Product Change Notice (PCN)

Subject: RZ/T2H&N2H Product Mask Revision Change

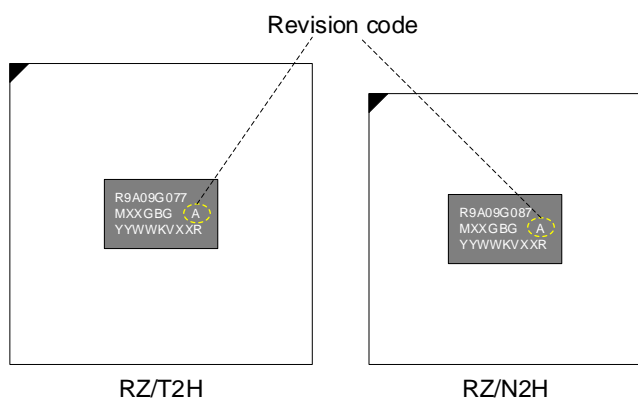
Revised products can be identified by the revision code ‘A’ marked on the package or by reading the value from Product Version (VER) in OTP. Additionally, for the revised products, the last digit of the booking part number will be changed from 0 to 1.
